## Planning Commission Staff Report

**Description:** **River Crossings (Holman Motorcars of St. Louis):** A Sign Package for a 15.841-acre tract of land zoned "PC" Planned Commercial District located north of Arnage Boulevard and south of Interstate 64. (17U240066, 17U240077, 17U240088, 17U520061, 17U520072, 17U520171, 17U520182, 17U520193)

Warren Sign, on behalf of Holman Motorcars of St. Louis, has submitted a request for an Amended Sign Package for the River Crossings subdivision. The Sign Package covers the entire River Crossings subdivision, however, the changes requested in the amendment are centered around Lots 7 and 8 of the subdivision. This Sign Package would establish flexible criteria that deviates from what the Unified Development Code (UDC) currently permits for both wall signage and freestanding signage.

Figure 5: Freestanding Signage Changes

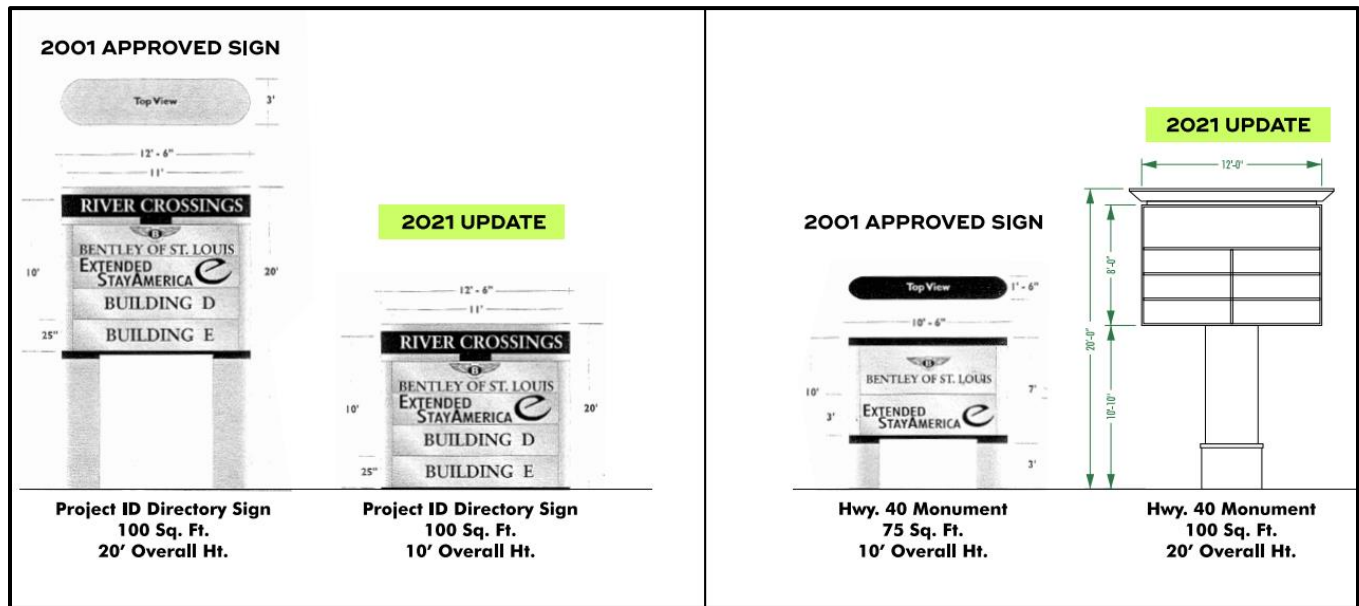
The Sign Package Amendment is requesting changes to two (2) of the monument signs. The requested changes are reflected in the table below:

Freestanding Signage – Interstate 64/Highway 40 Monument	Criteria	Location	Height	Area
	2001 Approved Sign Package	60’ setback	10’	75 ft <sup>2</sup>
	2021 Request	20’ setback	20’	100 ft <sup>2</sup>

Freestanding Signage – Chesterfield Airport Road Monument	Criteria	Location	Height	Area
	2001 Approved Sign Package	15' setback	20'	100 ft <sup>2</sup>
	2021 Request	15' setback	10'	100 ft <sup>2</sup>

Figure 6: Lot 7 Wall Sign Exception

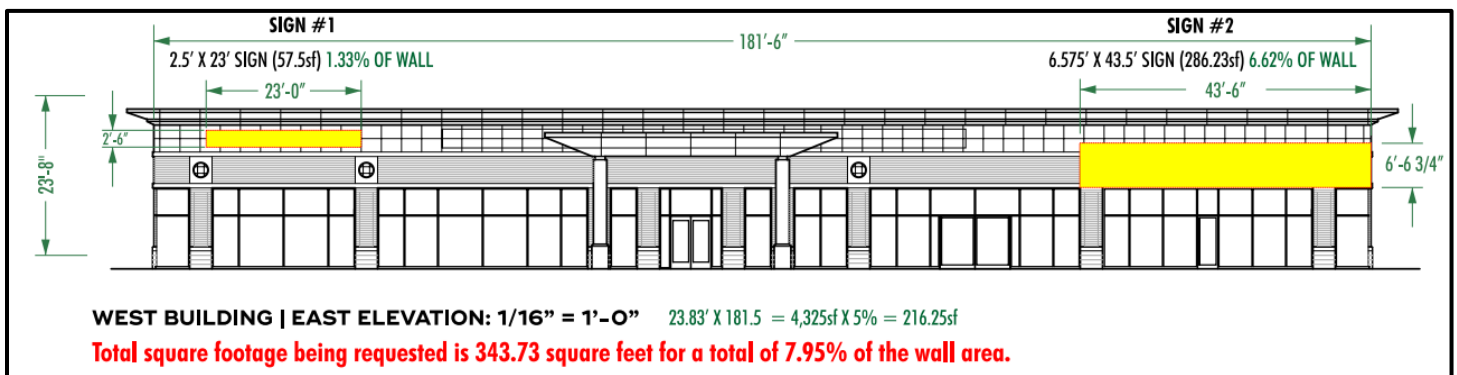
The Sign Package Amendment is requesting wall signage on each elevation of the buildings located on Lots 7 and 8 of River Crossings. All wall signage will adhere to the 5% maximum size apart from the east

elevation of the building on Lot 7 (9 Arnage Boulevard) and the west elevation of the building located on Lot 8 (1 Arnage Boulevard). The applicant is requesting two (2) wall signs permitted on the east elevation of the building on Lot 7 and six (6) signs on the west elevation of the building on Lot 8. While the request states that 5% of wall signage is permitted on each of the other elevations, less than 5% is being requested at this time. Below is the summary of the proposed wall signs for Holman Motorcars of St. Louis.

In total, the applicant is requesting one (1) additional wall sign that would be allowed for Lot 7 for a total of 7.99% of the wall area on the eastern elevation. Five (5) additional signs would be allowed for Lot 8 for a total of 7.99% of the wall area on the western elevation. Finally, the applicant is requesting wall signage be permitted on all elevations, but limited to 5% other than the exceptions listed above.

**Project ID Directory Sign**  
 100 Sq. Ft.  
 10' Overall Ht.

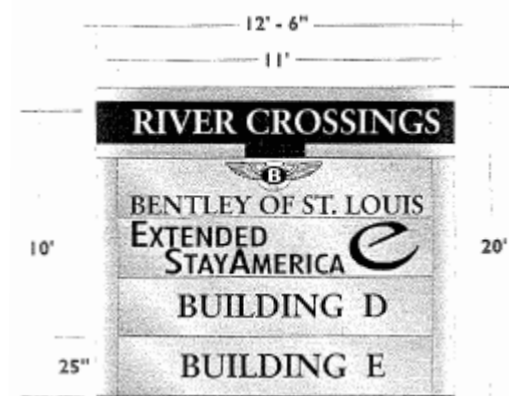
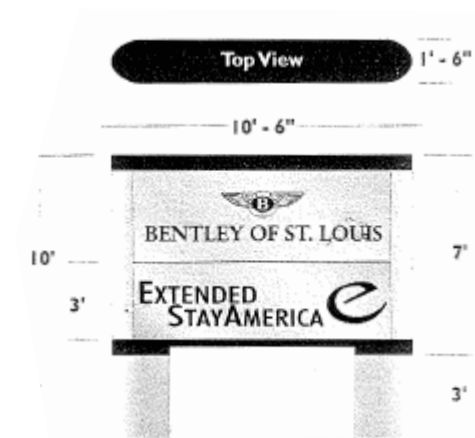
1. The 2001 plan allows for a 20' tall sign on the Airport Road frontage and a 10' tall sign on the I-64 frontage. We seek to reverse this and allow a 20' sign along the I-64 frontage and a 10' tall sign on Airport Road. We request the I-64 sign to be 100sf in area with a setback of 20' so the sign is visible without removing trees which obscure the facility. This is the only branding that faces I-64 other than a small 10sf Aston Martin wall sign which is obscured by trees. *The current CSP from 2001 has the interstate sign approved at 75sf and 10' tall. This is a variance of 25sf additional area and an additional 10' in height for readability to I-64's 2021 conditions.*

*There shall be two (2) Project ID – Directory Signs. The sign fronting Airport Road shall not exceed 10' in height, 12'-6" in width and 100 sq. ft of graphic area per face. The sign fronting I-64 shall not exceed 20' in height and 100sf of graphic area per face. These internally illuminated signs shall be designed to the development standard and consistent in materials, construction and design.*

# WEST BUILDING | EAST ELEVATION | 9 ARNAGE BLVD.

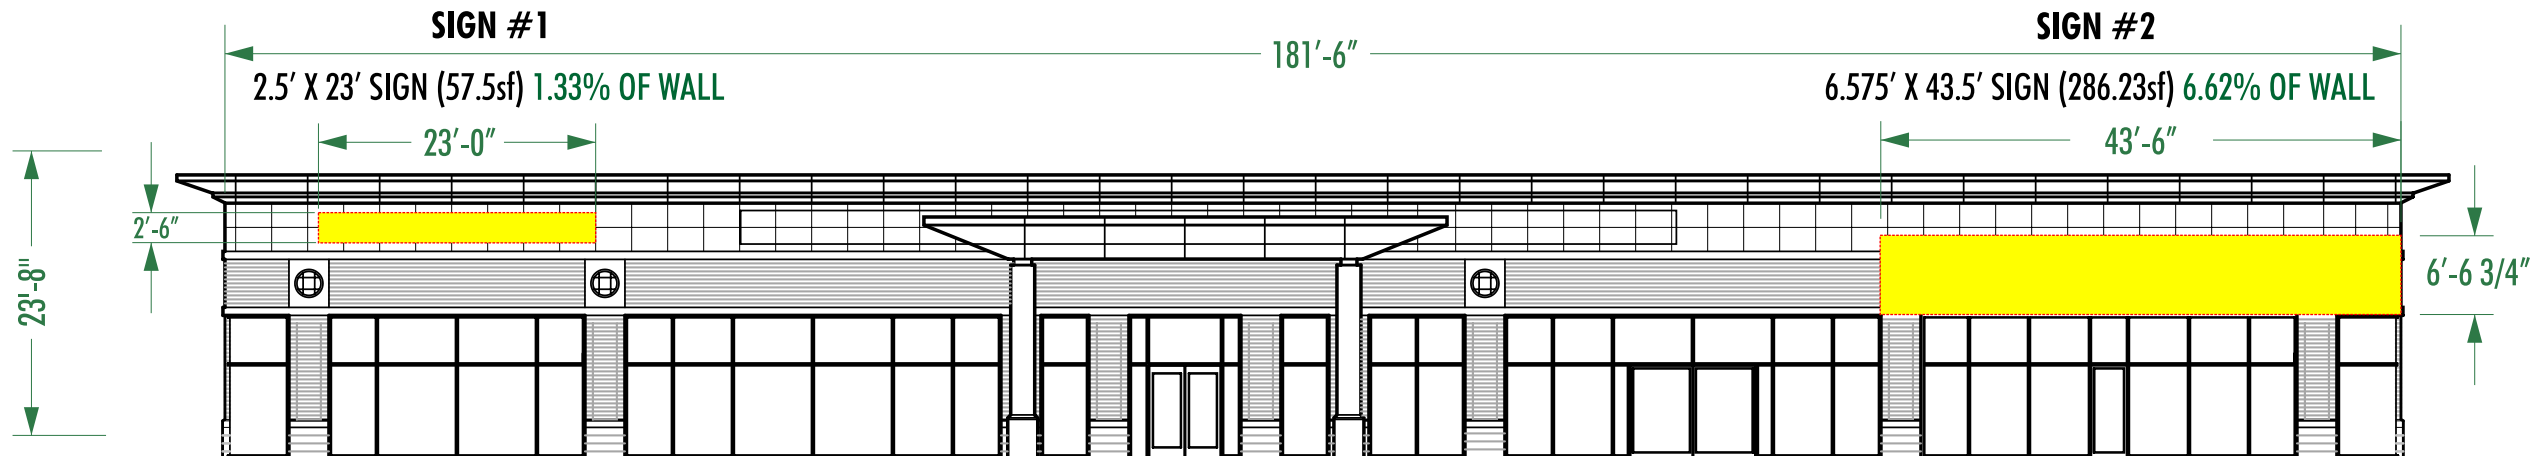
WEST BUILDING | EAST ELEVATION:  $1/16'' = 1'-0''$   $23.83' \times 181.5 = 4,325sf \times 5\% = 216.25sf$   
**Total square footage being requested is 343.73 square feet for a total of 7.95% of the wall area.**

# EAST BUILDING | WEST ELEVATION | 1 ARNAGE BLVD.

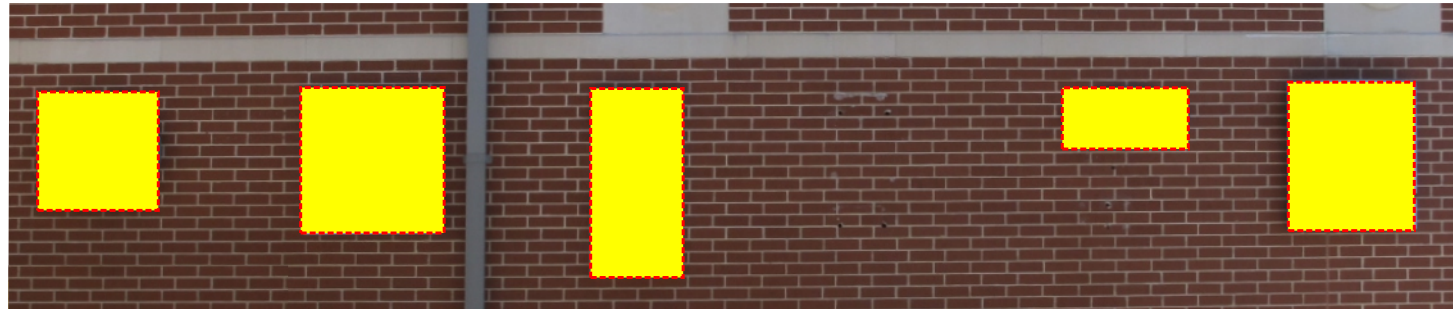
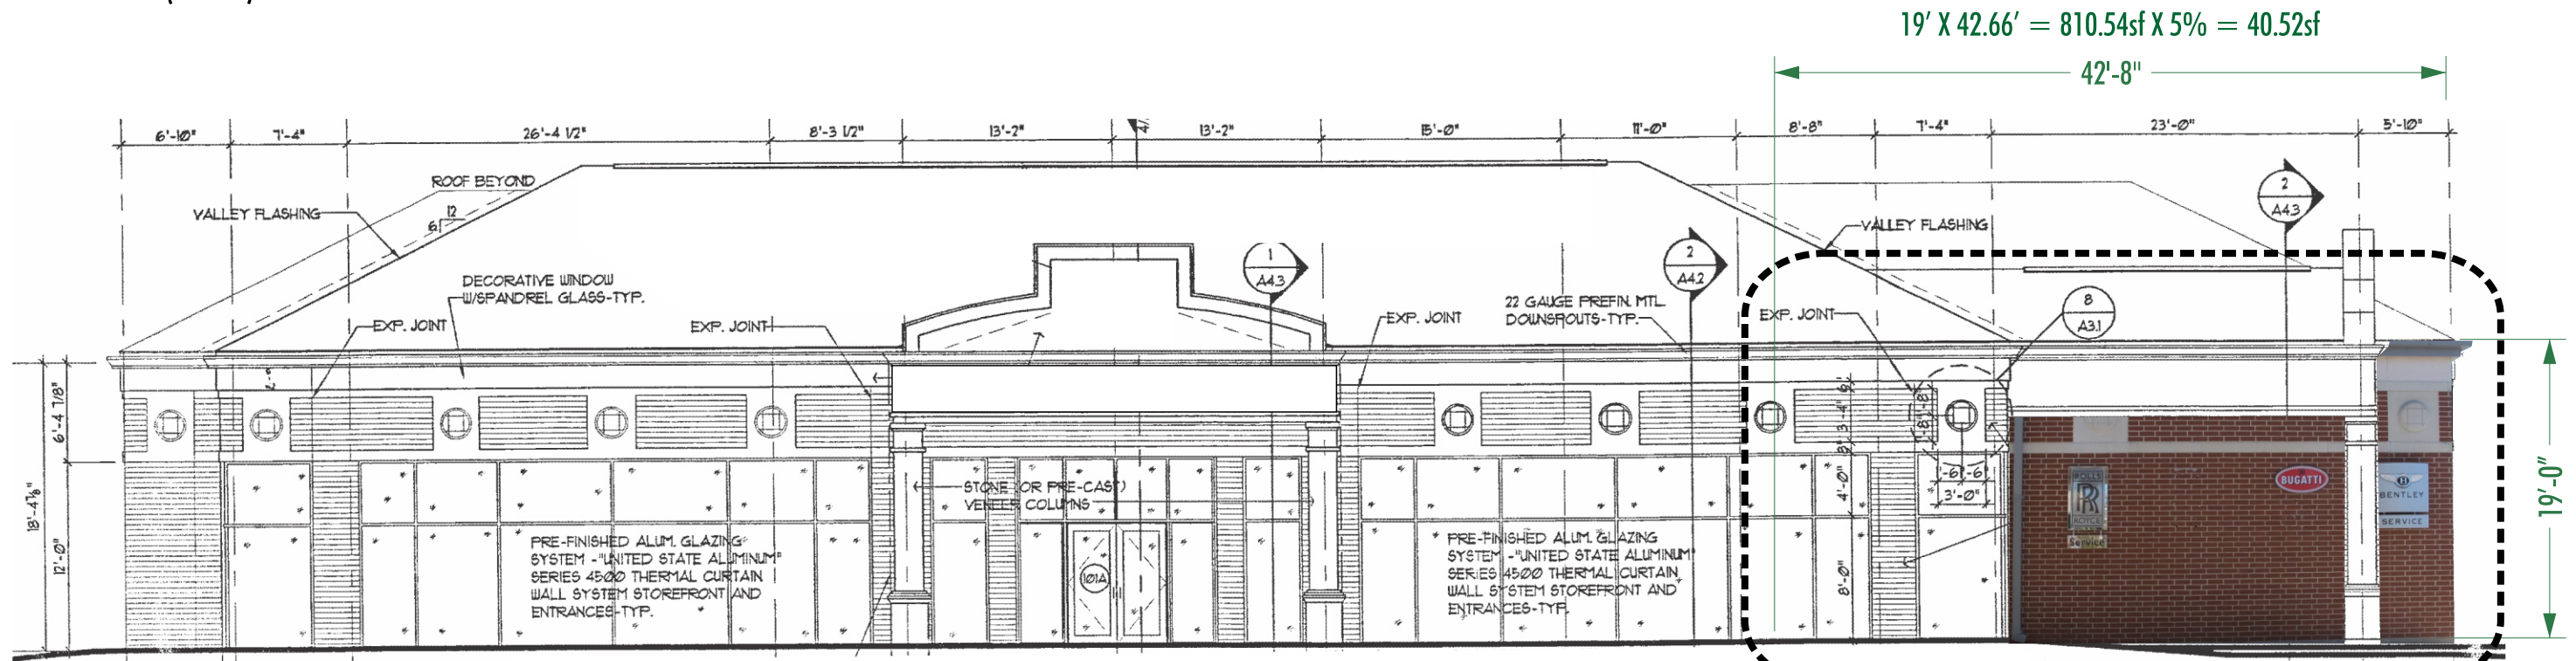
**SIGN ELEVATION @ SERVICE CORRIDOR: 3/16" = 1'-0"**  
 (60.32sf) 7.4% OF WALL

**There is a total of 60.32 square feet of signage, totaling approximately 7.4% of the wall area.**
